## 35-TYPE CONVERTER SETS — ADJUSTMENTS

*APPARATUS AFFECTED:* 35A, 35B, 35D, 35E, 35F, 35G and 35H Converter Sets.

- (1) To simplify adjustment methods and requirements.
- (2) To revise and update wiring diagrams.

**8.19 GEAR MECHANISM**

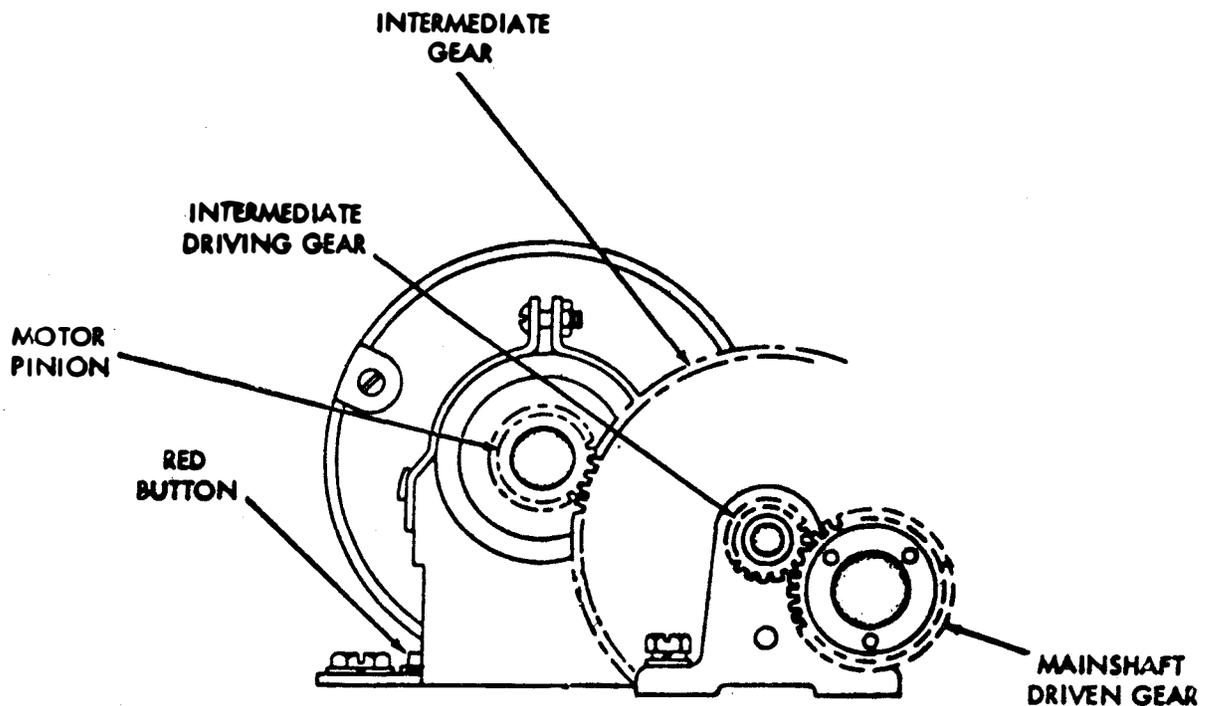
(1A) *Section 570-106-700, Issue 3, Page 30, Paragraph 3.19*

(A) Tape Reader Gear Backlash

The location of subparagraph (A) on page 30 has been changed and will read as subparagraph (B) Tape Reader Gear Backlash.

The requirement (A) Tape Reader Gear Backlash has been changed:

From: "Only a perceptible amount of backlash between main shaft driven gear and intermediate driving gear."

To: "Only a perceptible amount of backlash between main shaft driven gear and intermediate driving gear at point where backlash is least."

(B) Intermediate Shaft

The location of subparagraph (B) on page 30 has been changed and will read as subparagraph (A) Intermediate Shaft.

The requirement of Min. 0.015 inch—Max. 0.020 inch has been deleted.

"To Adjust" of new (A) Intermediate Shaft, has been changed:

From: To Adjust.

Position the intermediate shaft assembly to the forward plate loosened.

To: To Adjust.

Loosen the two intermediate gear bracket screws and position intermediate gear bracket.

The note to subparagraph (B) Intermediate Shaft, has been changed:

From: Note: Intermediate shaft adjustment required only on miniaturized base.

To: Note: In some cases, it may be necessary to loosen the motor mounting screws and position the motor to meet the requirements.

The new requirements are shown on attached sheet which should be used as temporary addendum to page 30, Section 570-106-700.

ONLY A PERCEPTIBLE AMOUNT OF BACKLASH BETWEEN THE MOTOR PINION AND INTERMEDIATE GEAR AT POINT WHERE BACKLASH IS LEAST.

LOOSEN THE TWO INTERMEDIATE GEAR BRACKET SCREWS AND POSITION INTERMEDIATE GEAR BRACKET.

**NOTE:** IN SOME CASES IT MAY BE NECESSARY TO LOOSEN THE MOTOR MOUNTING SCREWS AND POSITION THE MOTOR TO MEET THE REQUIREMENT.

ONLY A PERCEPTIBLE AMOUNT OF BACKLASH BETWEEN MAINSHAFT DRIVEN GEAR AND INTERMEDIATE DRIVING GEAR AT POINT WHERE BACKLASH IS LEAST.

LOOSEN THREE TAPE READER MOUNTING SCREWS AND POSITION TAPE READER.
